UNITED STATES PATENT AND TRADEMARK OFFICE

APPLICATION NO.	FILING DATE	FIRST NAMED INVENTOR	ATTORNEY DOCKET NO.	CONFIRMATION NO.
10/712,407	11/13/2003	Thomas P. Hartness	HII-108	6828

Office Action Summary

FIG. 1

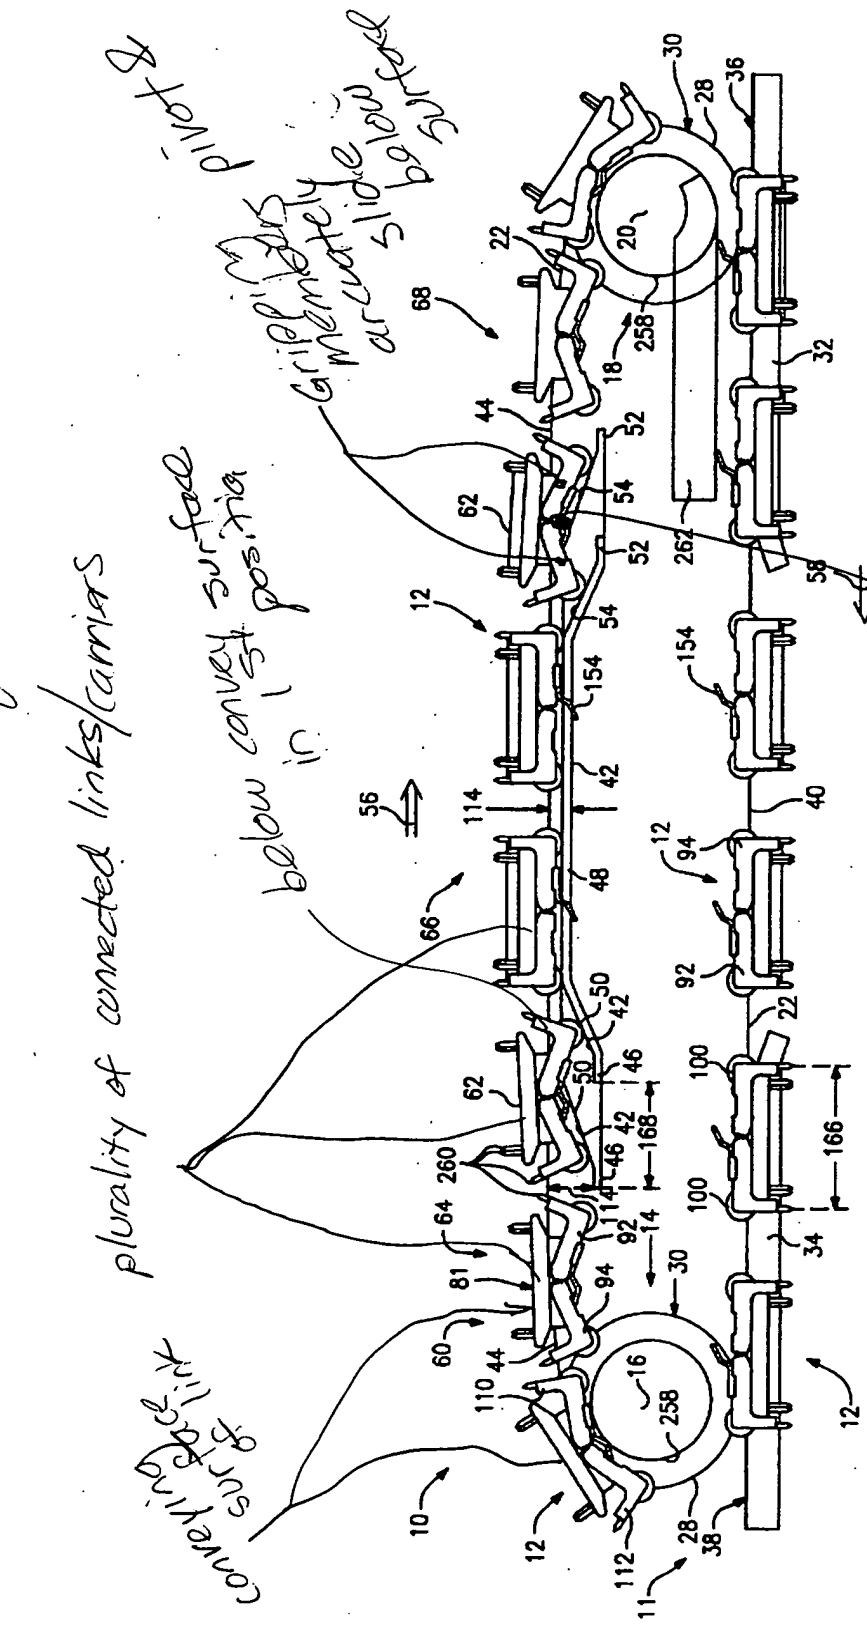
See the attached marked up copy of Raque figure 1 depicting the claimed features.

plurality of connected links/carriers

Grip links
completely
arcuately
slide
by itself

below convey surface
in 1st position

conveying
surface

pivot axis to convey direction
